## BRIEFING SUMMARY SHEET

DEVELOPMENT ASSESSMENT CASE NUMBER: CD-2012-0002 – Sunfield PUD

Presentation of a Project Assessment Report for the Sunfield Planned Unit Development, also known as Sunfield Municipal Utility District No. 2, located at the southwest corner of Turnersville Road and South Turnersville Road, within the Rinard Creek, Plum Creek and Onion Creek Watersheds.

OVERALL  
DEVELOPMENT  
ASSESSMENT PLAN

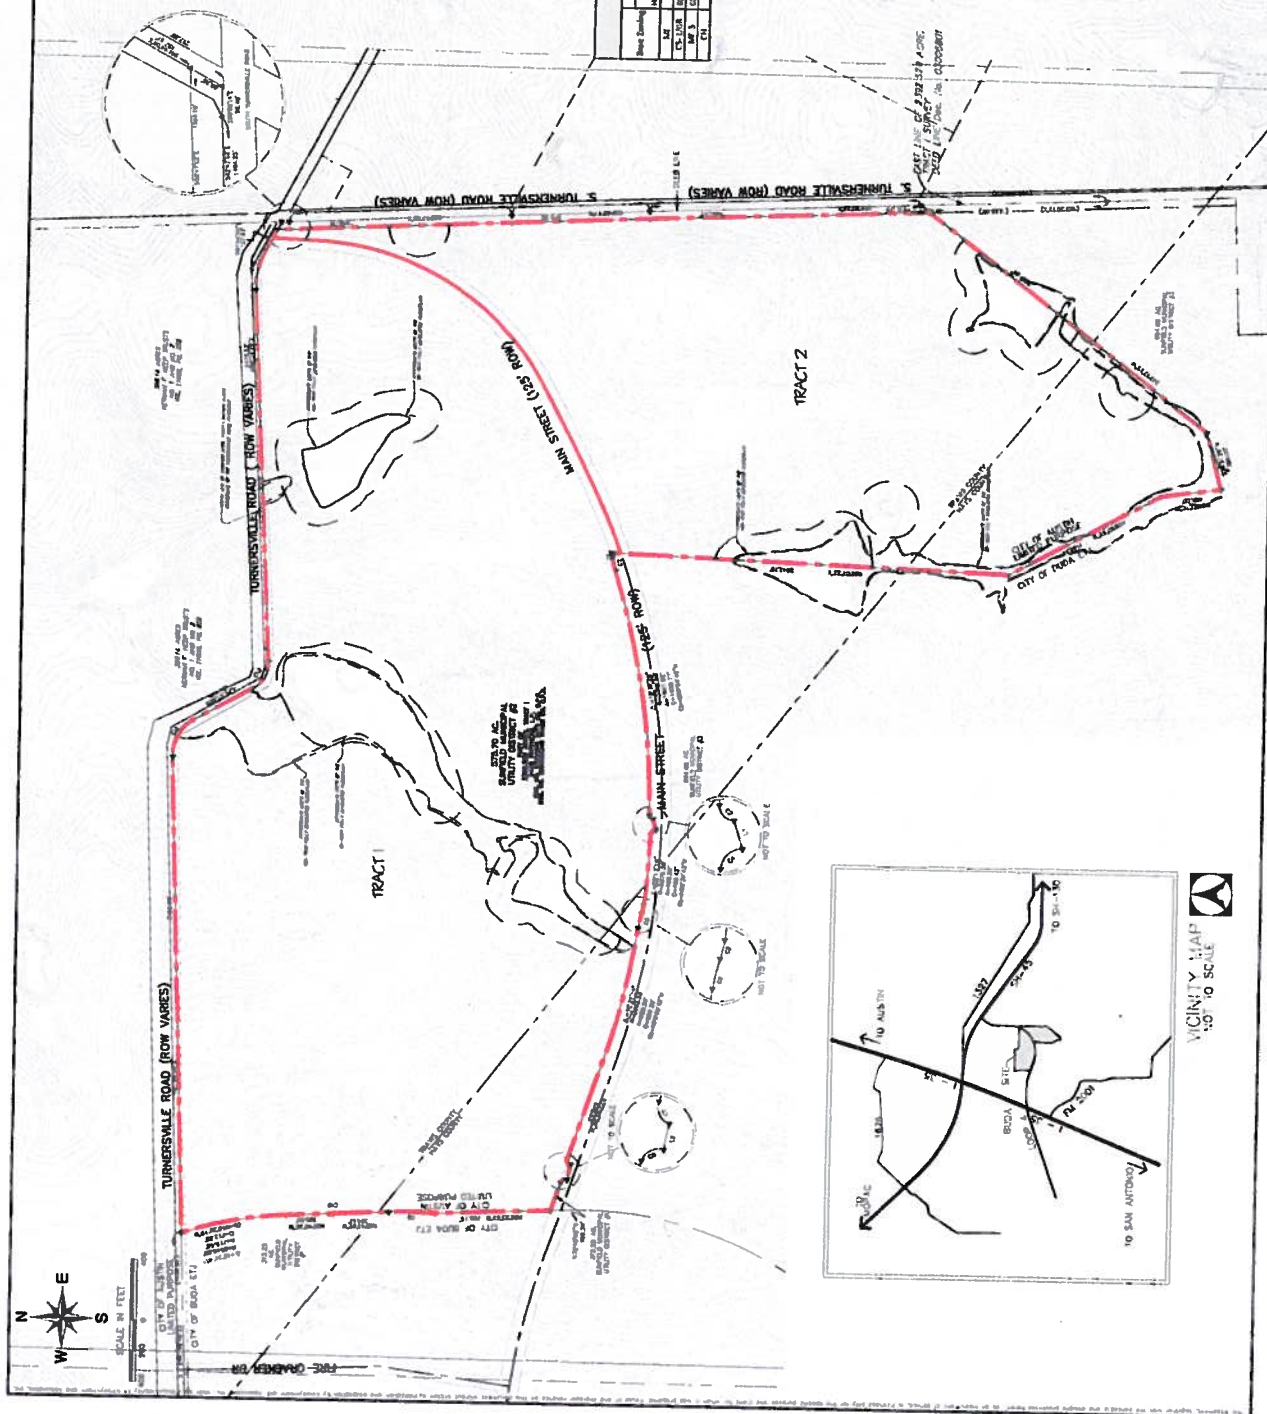
HG1- Please clearly label and identify with shading and/or hatching all Critical Environmental Features and their associated setback on all plan sheets.

information). For context, please label the adjacent MUDs (#1 and #3) on the land use plan.

- ZN 5. Please provide more detail on the PUD Land Use Plan about how the land uses will be distributed on Tracts 1 and 2, including the proposed fire station tract. The Winfield MUD #2 Land Use Plan is a good starting point.

- ZN 6. Please show the proposed roadway network on Tracts 1 and 2, and proposed connections to adjacent properties. The Winfield MUD #2 Land Use Plan is a good starting point.
